Staff Report & Recommendation

Historic Preservation Board

SUBJECT: HPB25-0662 a.k.a. HPB 7490, **3425 Collins Avenue.**

Previously approved guardhouses

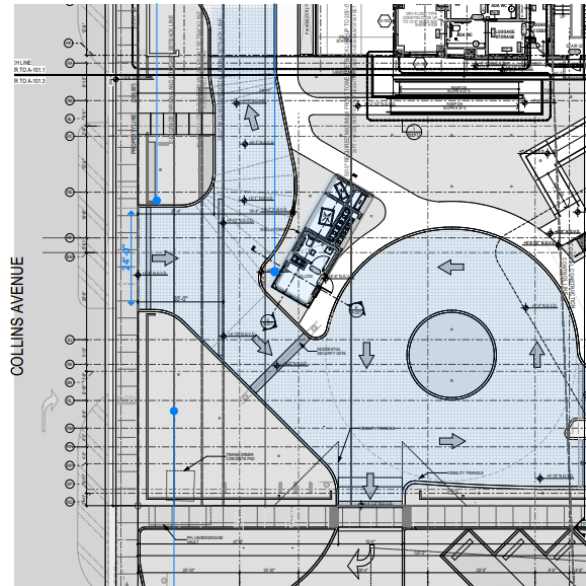
Staff is supportive of the consolidated guardhouse function and has no objection to the proposed design which incorporates landscaping consistent with the previous approval. Additionally, staff is extremely supportive of the elimination of the exit drive onto Collins Avenue which will significantly enhance the pedestrian experience and safety.

Diagram of original design inspiration and image of folded paper streamer

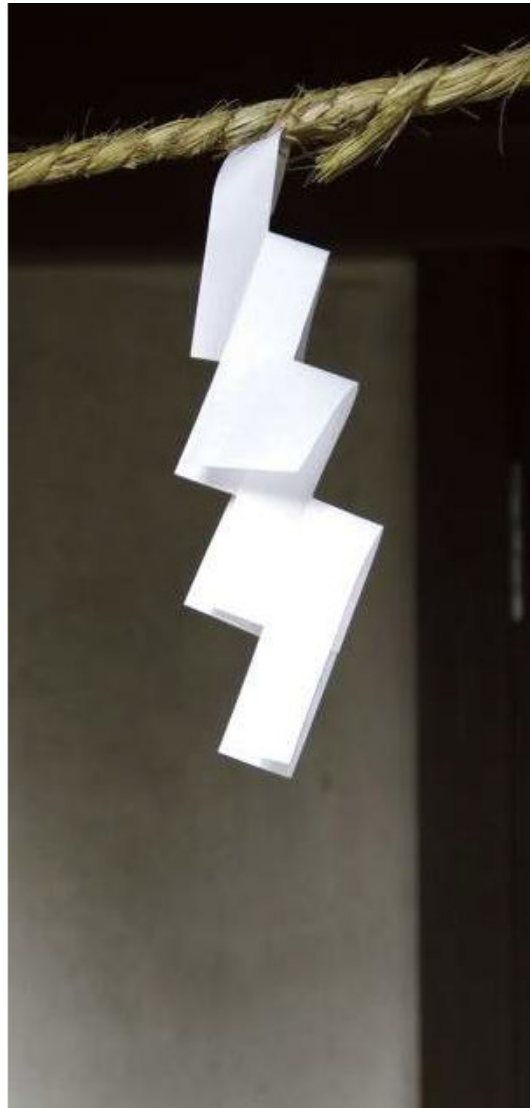
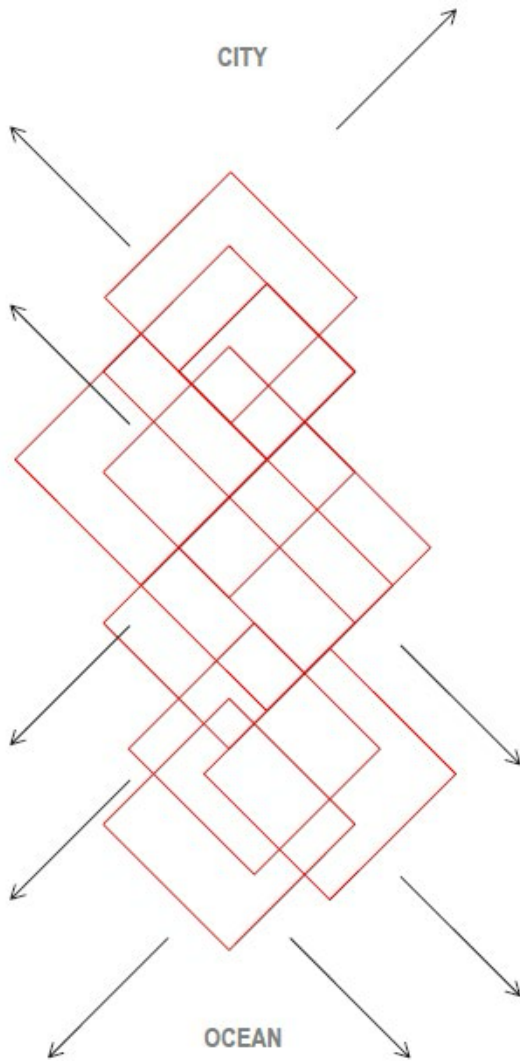
The detached residential addition was approved by the Board in 2021 and designed by renowned architect Kengo Kuma. According to the applicant, the design has been inspired by the geometry of Japanese folded paper streamers known as Shide, as well as the rhythm and proportions of Art Deco architecture. The applicant is currently proposed to modify the façade design by eliminating the vertical lattice screening elements.

The screening was approved on the north, west and south sides of the building. Since permit approval, the design architect, in collaboration with the architect of record and the structural engineer have worked to finalize the details of this element of the design. As initially conceived, the individual vertical elements were meant to have a profile of 1/2" x 3". However, as indicated by the applicant, after a thorough engineering analysis, the profile of these elements would have to be six times larger than original conceived. Additionally, the structural attachment components would also require significant upsizing.

As a result of the upsizing, the delicate design intention of these elements is lost. Additionally, staff believes that the underlying façade design maintains a reasonable degree of vertical expression consistent with approved design. Finally, staff believes that the elimination of the screening helps to better express the original folded paper design inspiration. As such, staff has no objection to the elimination of the vertical screening elements.
